BCC DS
RECEIVED
28-SEP-2026
APPLICATION REF
A007121709

Re: Request to Make a Change to a Development Approval over land located at 55, 59, 61 & 63 Tingal Road, Wynnum also described as Lots 99, 100, 120 & 121 on SP301032
Council Reference: A006831135

On behalf of Groove Developments No 1 Pty Ltd, we hereby request to make a change to the abovementioned development approval under s78 of the Planning Act 2016 ('the Act').

Figure 5: Extract of A006831135 Approved Basement Plan

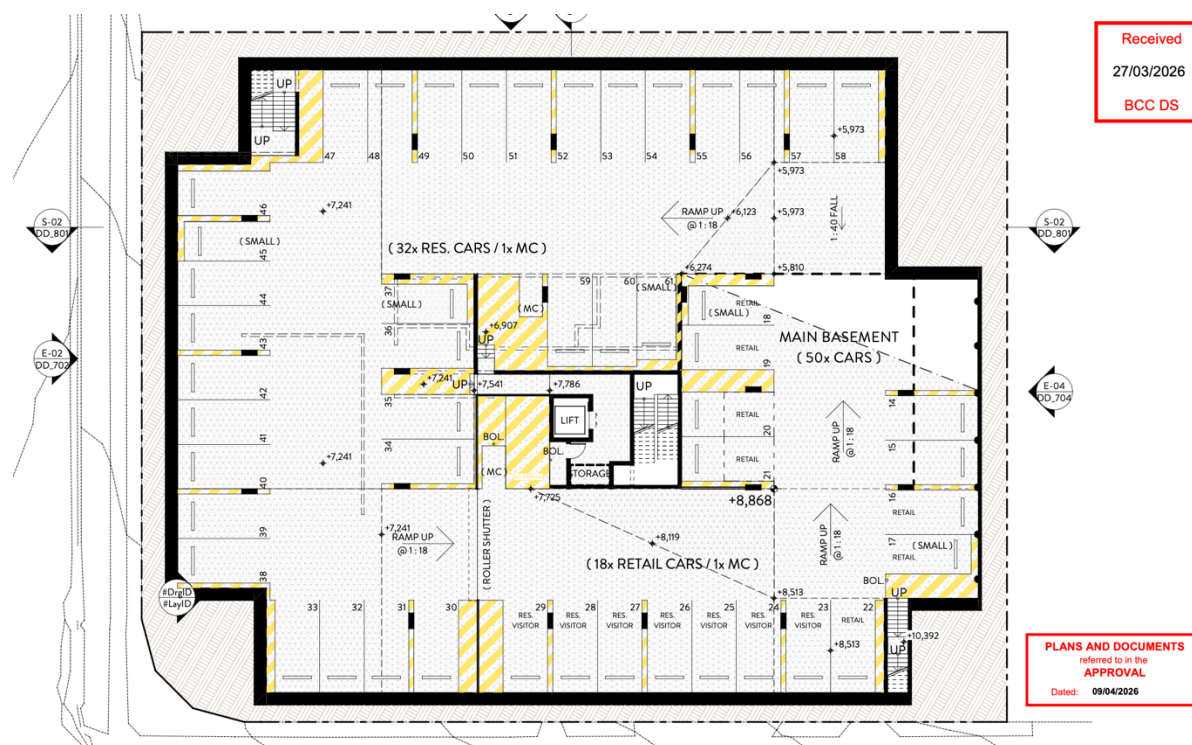
- Reallocating six (6) residential car parks as retail car parks, resulting in an overall allocation of 51 residential car parks and 29 retail spaces.
- Reconfiguring the basement level design to relocate the roller shutter door so all visitor and retail spaces are unimpeded 24 hours a day, 7 days a week.

Figure 7: Extract of Proposed Basement Plan

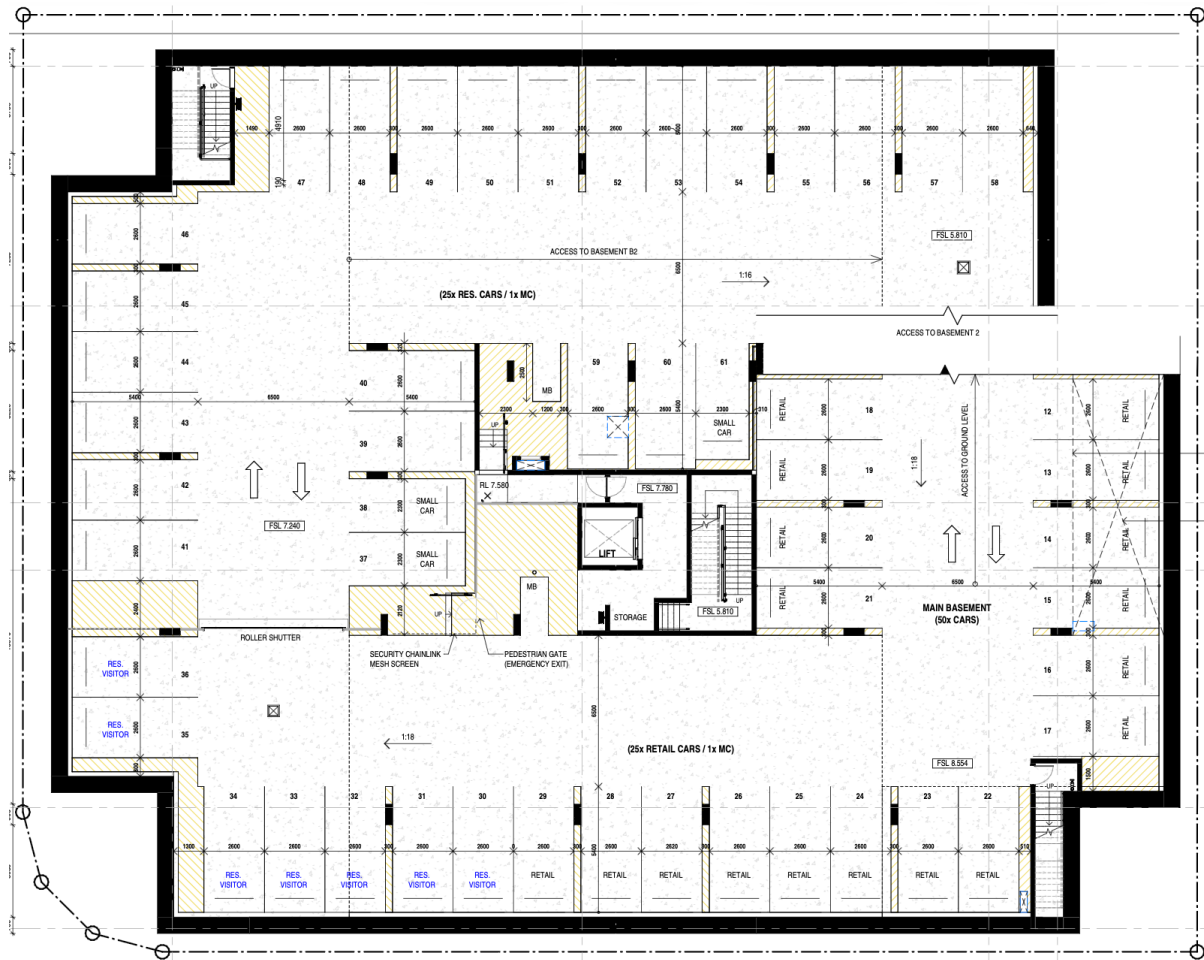
- Extending the extent of brickwork on Levels 2 and 3 of the south-western elevation (fronting Tingal Road) to balance the built form
- Introducing inverted arch forms to the Level 5 balconies, which mirror the arches on the ground level and the curved ends of the decorative brickwork on the levels between. This is considered to create a consistent architectural language from ground to top, visually tying the upper level to the lower levels when the building is read from the street.
